**Corrigendum to the proposed 03 series of amendments to Regulation No. 96**

Document ECE/TRANS/WP.29/GRPE/2011/11 - (European Commission) Proposal for draft 03 series of amendments to Regulation No. 96 has been introduced for consideration at the 62<sup>nd</sup> session of GRPE in June 2011. After the submission of this official document in March 2011, some editorial errors have been identified, which should be corrected without delaying the process of adoption of the proposed 03 series of amendments to Regulation No. 96.

**Model B**

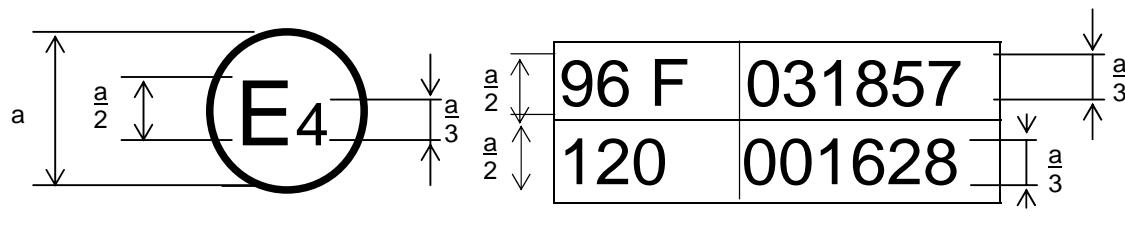
Annex 3, model A and B, correct to read:

Justification: The provisions for approval marks have to be updated according to the new 03 series of amendments to Regulation No. 96.

The above approval mark affixed to an engine shows that the engine type concerned has been approved in the Netherlands (E4) pursuant to Regulations Nos. 96 (according to the level corresponding to power band F) and 120. The first two digits of the approval number indicate that, at the dates when the respective approvals were granted, **Regulation No. 96 was in its amended form (03 series of amendments) and 120 in its original version**.
